10 Ferncroft Avenue, NW3 Application 2020/0113/P

Delegated Report (Members Briefing)	Analysis sheet		Expiry Date:	06/03/2020
	N/A / attached		Consultation Expiry Date:	29/03/2020
Officer		Application Number(s)		
Gavin Sexton		2020/0113/P		
Application Address		Drawing Numbers		
10 Ferncroft Avenue London NW3 7PH		Refer to decision notice		
Proposal(s)				
Erection of single storey rear extension and enlargement of rear garden terrace; installation of one dormer window to the front and one dormer to the rear roof slope; replacement of pebbledash to front bay window with hanging tiles; paving of driveway.				
Recommendation(s):	Grant conditional planning permission			
Application Type:	Householder Application			
Consultations				
Summary of consultation responses:	<p>Site notices were placed on 28th February for three weeks, on Ferncroft Avenue and Hollycroft Avenue.</p> <p>A notice was placed in the press on 5th March, continuing the statutory consultation until 29th March 2020.</p> <p>No responses were received.</p>

Image 7: Existing (left) and Proposed (right) site plan.

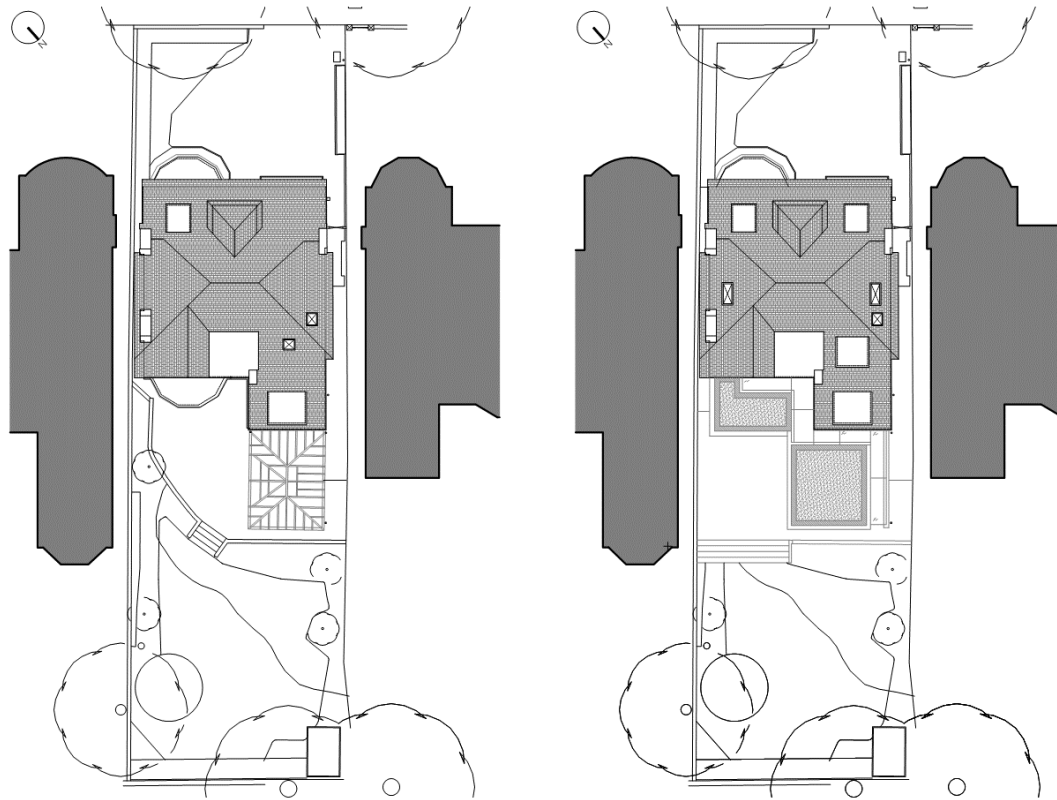
2. In this case, the tree roots are threatened by the extension and terrace foundations (not detailed incidentally) but the tree could be retained with a slight reduction of the extension depth and basic low-grade piling to avoid the main roots.

3. If the tree's removal is unfortunately consented, we would ask for compensatory planting on the greatly enlarged hard-paved terrace.

4. We regret the demolition of the rear bay for replacement by the extension without a great gain in floor area. Original features of these houses should be respected and retained if at all possible.
5. That terrace and the longer north side extension threaten excessive garden take-up especially should the property later boast an outbuilding. More care should be exercised by architects in such work.
6. The proposed side elevation large glaze high-level strip is likely to offer disturbance to no.8's rear garden and seems superfluous.

1.7 Minor alterations are proposed to the rear garden to enlarge the existing terrace which sits two steps below the remainder of the garden. These changes would result in the loss of c.12sqm of planted bed, leaving c.180sqm (94%) of untouched rear garden and soft landscaping. This minor reduction in soft planted area would retain the soft landscaping character of the rear plot, and would accord with the NDP policy BG1 (Rear Gardens and Ecology).

1.8 A small cherry tree would be removed from the planting bed to accommodate the extension to the terrace. The tree is currently too small to make a significant contribution to the rear garden and a condition (see condition 5) would be added to secure its replacement with a Wild Service in 'heavy standard 12-14cm' as a minimum, which will provide greater biodiversity than a Cherry cultivar.

1.11 The Hampstead CAAC have requested that planting is secured on the enlarged patio. However planting in moveable pots is not development and it is not considered reasonable or enforceable to require that pots be planted and maintained in that area. The rear garden would retain its largely soft landscaped character.
